**EXPLANATION OF SIGNIFICANT DIFFERENCES
FOR THE TYBOUTS CORNER LANDFILL SITE
NEW CASTLE COUNTY, DELAWARE**

MAY 1992

Tybouts Corner Landfill Superfund Site New Castle County, Delaware

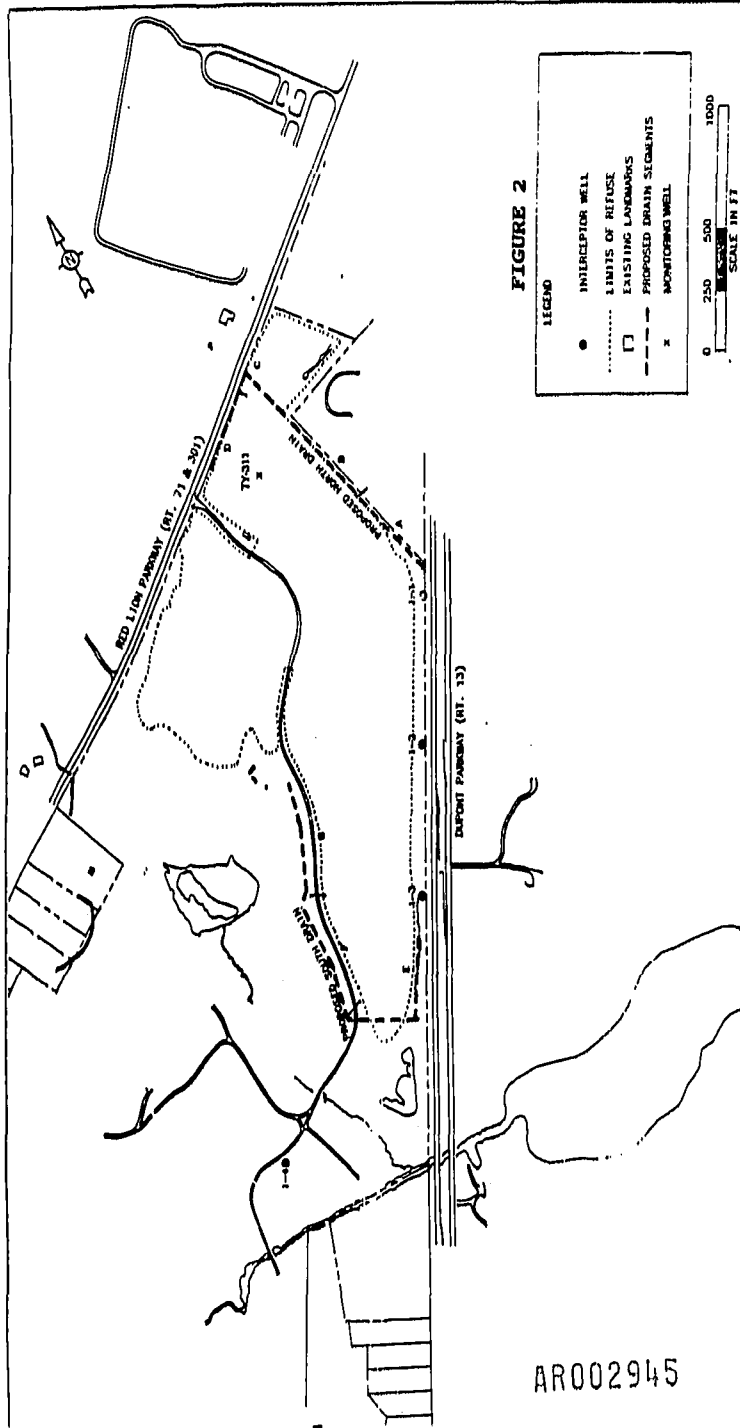
The 1986 ROD calls for the installation of a cap and groundwater controls. The groundwater controls described in the 1986 ROD consist of upgradient (north) and downgradient (south) subsurface drains and a system of interceptor wells designed to pump contaminated groundwater emanating from the downgradient side of the Site and the offsite plume in the PN-1 Sand. The 1986 ROD specifies that contaminated groundwater will be treated prior to discharge into the local publicly owned treatment facility. The subsurface drains and interceptor well locations as conceptualized in the 1986 ROD are shown on Figure 2.

FIGURE 3

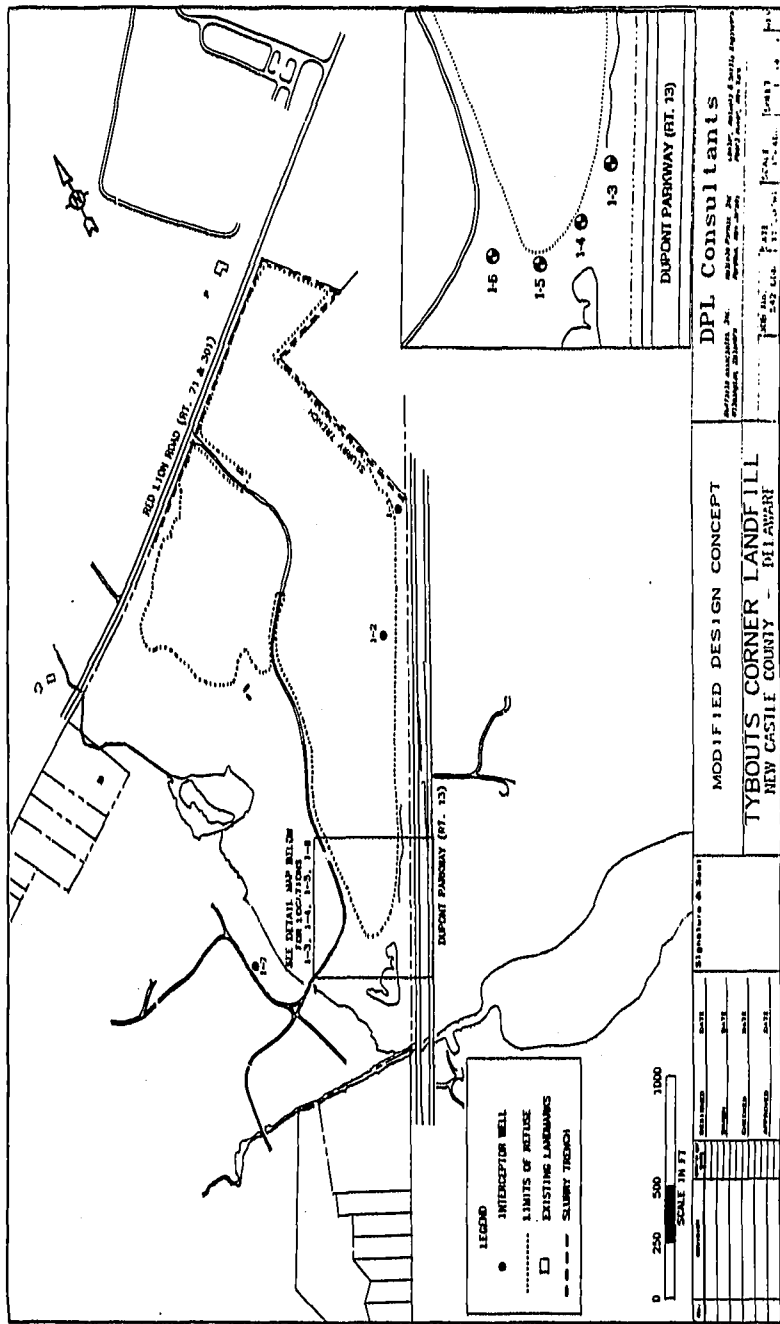
Current design work has led to design modifications which include use of a passive slurry trench as opposed to the northern drain (see Figure 3). As opposed to the drain system, which would collect groundwater intercepted at this location, the slurry trench will block and divert groundwater away from the main landfill. Recent groundwater data obtained from the area to the north of Route 71 indicates that groundwater control on that parcel is influenced by a westward-flowing tributary to Pigeon Run. This tributary controls the water table elevation and hence ambient groundwater flow in the area. The revised MODFLOW model reflects that groundwater flow beneath Route 71 into the main landfill to the south would be minimal. A slurry trench can be as effective as the drain system in intercepting this groundwater.

- (1) **Overall Effectiveness** - The projected effectiveness and reliability of the northern drain was good. Unless the drain clogged or its pumps failed, the drain would have reliably intercepted groundwater flow. This groundwater was to have been pumped away from the main landfill for treatment. The slurry trench will be as effective as the drain in preventing groundwater from entering the main landfill. The preliminary extent of the slurry trench concept is shown on Figure 3.

- (1) Overall Effectiveness - Due to the absence of the aquitard at the southern edge of the main landfill, the effectiveness of the southern drain contemplated by the 1986 ROD is reduced. Pump tests at the southern-most test interceptor well along Route 13 have shown that operation of this well would dewater the southern drain, which is located in the Columbia formation. In lieu of the southern drain, a system of wells to collect leachate emanating from the main landfill will be designed to have overlapping zones of withdrawal and operated to complement the interceptor wells specified in the ROD. In the long term, pumping from multiple wells with overlapping zones of withdrawal provides better control of groundwater flow in the PN-1 Sand and will also collect any leachate emanating from the main landfill in the Columbia formation. Conceptual locations of the proposed interceptor wells are shown in Figure 3.

The slurry trench shall be designed, constructed, operated, and maintained in a manner sufficient to block and divert all groundwater which would have been intercepted by the northern drain identified in the 1986 ROD away from the main landfill.

The interceptor wells shall be designed, constructed, operated, and maintained in a manner sufficient to capture the offsite plume of contaminated groundwater in the PN-1 Sand and to prevent the further spread of the contaminant plume by intercepting and collecting effluent from the main landfill.

FIGURE 4

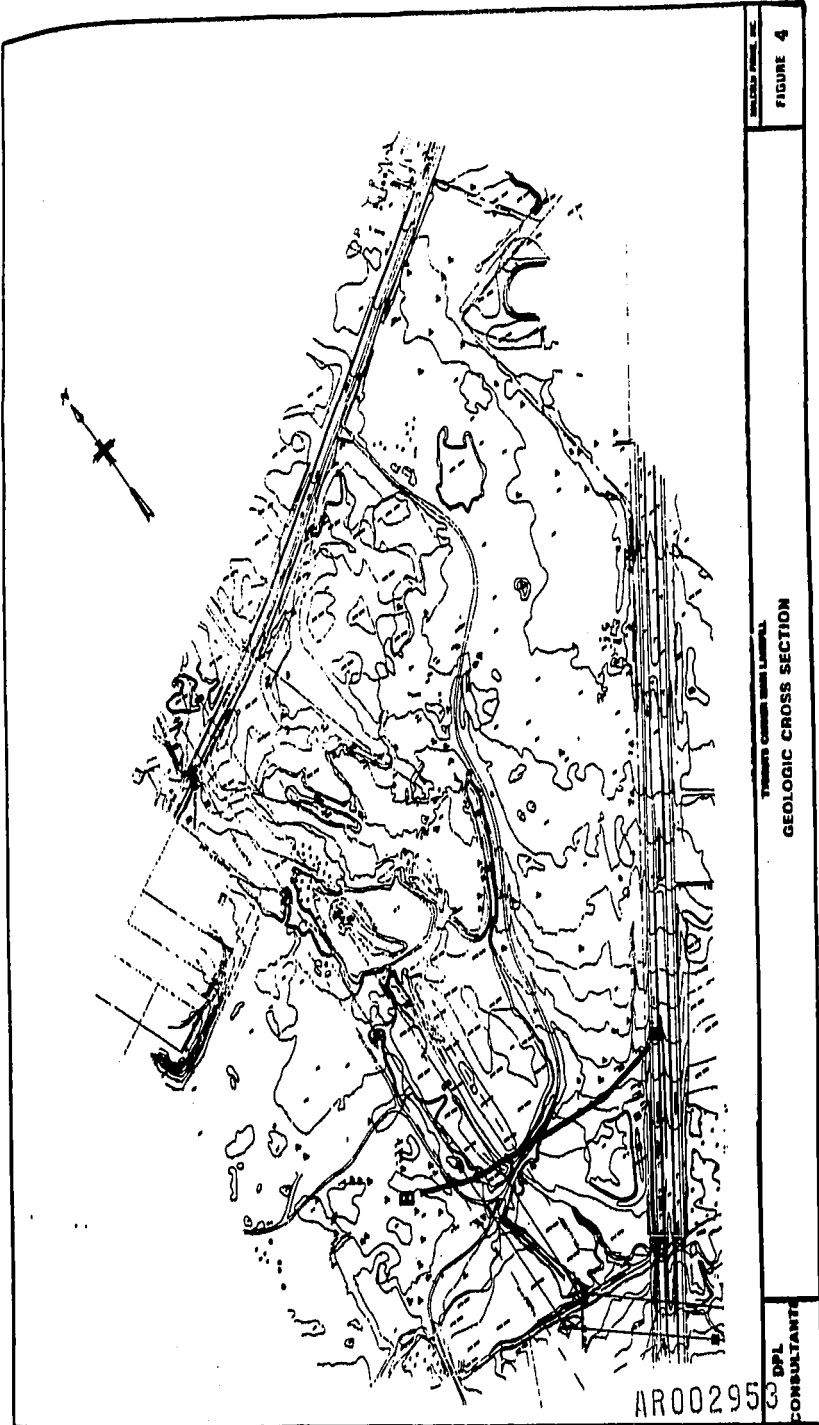
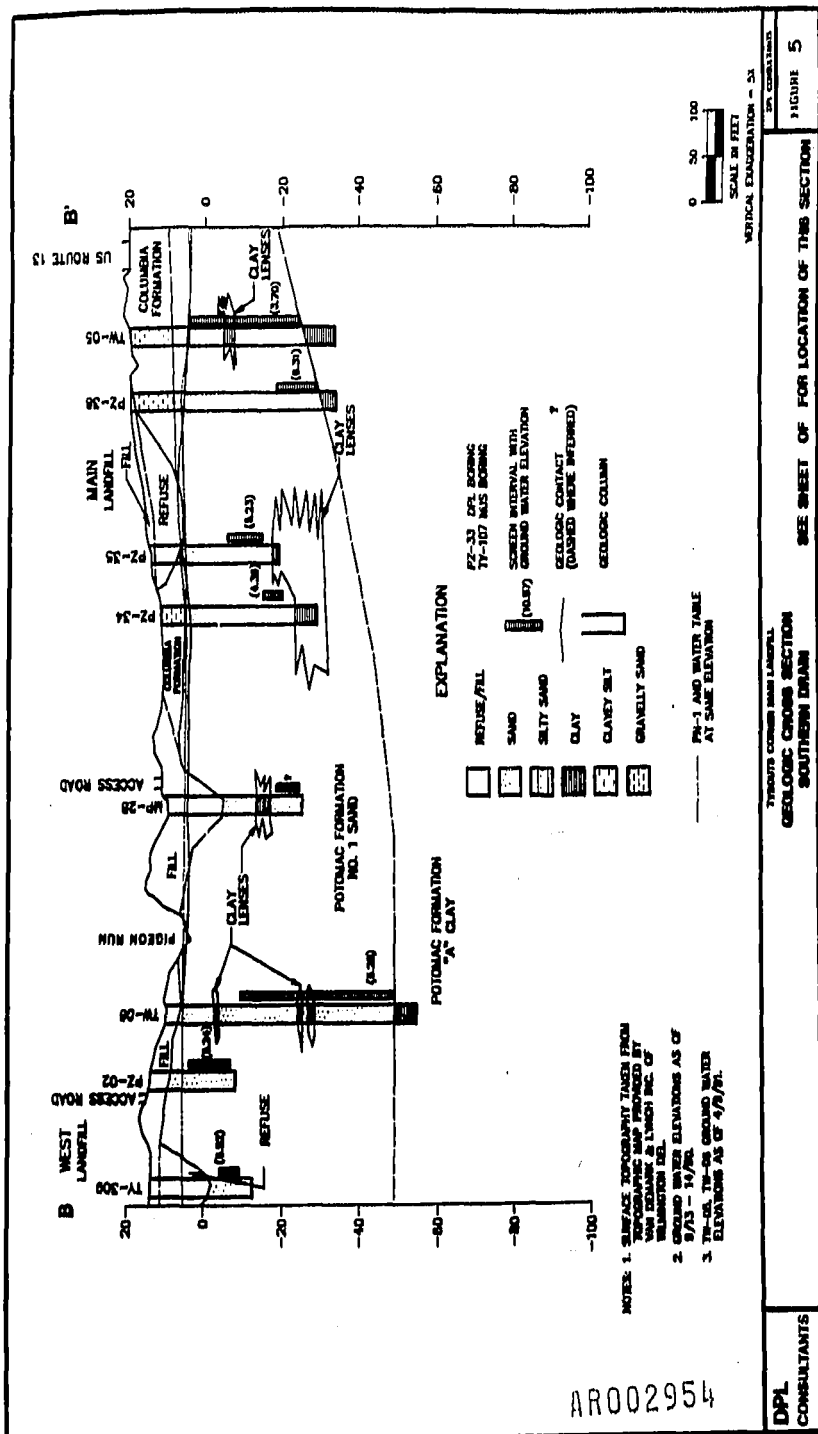
According to the RI/FS, the aquitard in the southern portion of the Site was believed to be shallow (less than 20 feet below grade). Saturated refuse was believed to rest on top of this aquitard. During the predesign exploration (borings drilled in 1990), the aquitard was found to be missing at the southern edge of the main landfill where the downgradient drain was to have been constructed. See Figures 4 and 5 for a geologic cross-section through the southern section of the main landfill.

As stated above, the southern drain was conceptualized in the ROD to collect existing leachate perched at the south end of the main landfill on the aquitard. Information obtained during pre-design hydrogeologic explorations suggests that the effectiveness of the drain in skimming leachate as it leaves the main landfill is reduced since the aquitard is missing beneath the proposed southern drain. In addition, pump tests at the southern-most test interceptor well along Route 13 (see Figure 3) indicate that the operation of this interceptor well would likely prevent effluent from reaching the southern drain.
